**Subject: Review of Comments on CUP #1200  
Public Hearing – to Consider Approving Environmental Review #20-20 (CEQA  
Section 15162 Findings) and Approving Amendments to Resolution 2015-33**

Review of Initial Study #04-02

**Figure 2**  
Relationship to City Planning Boundaries

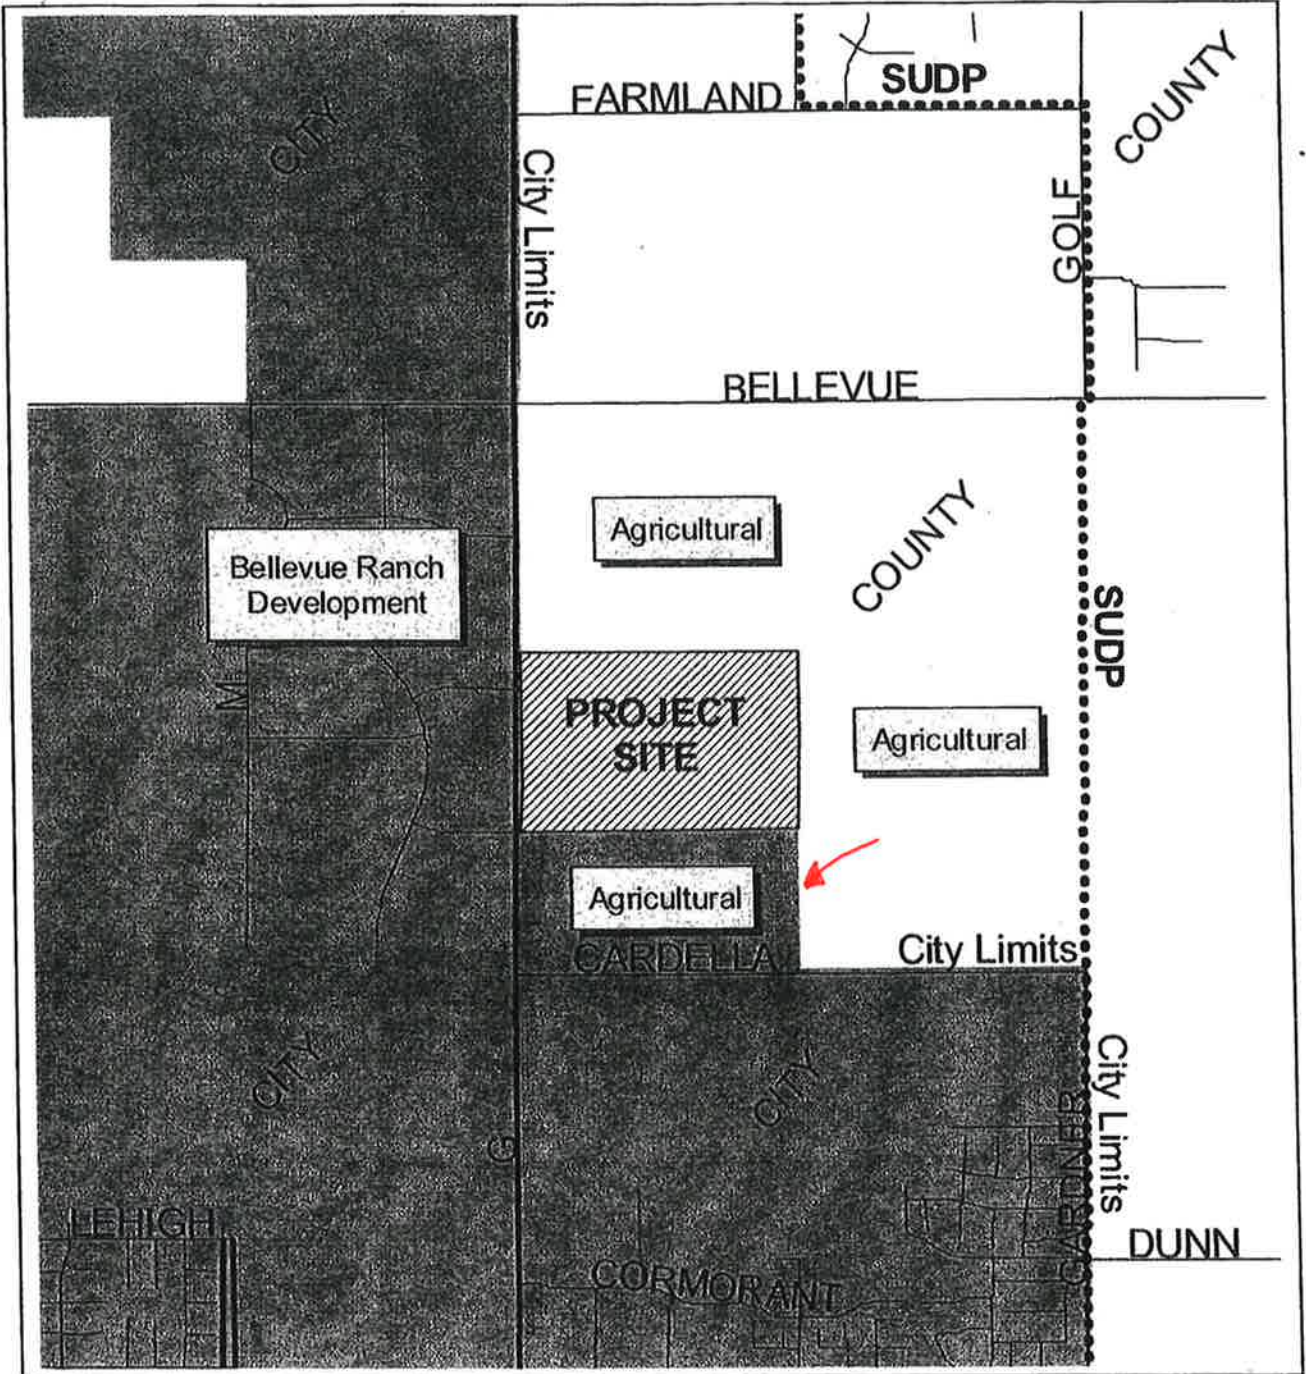
The Project description does not include the Bandoni property to the south, nor does it include the property as being required for support services; roads/access.

Initial Study shows Bandoni property as in agriculture, not developed. Fig. 2
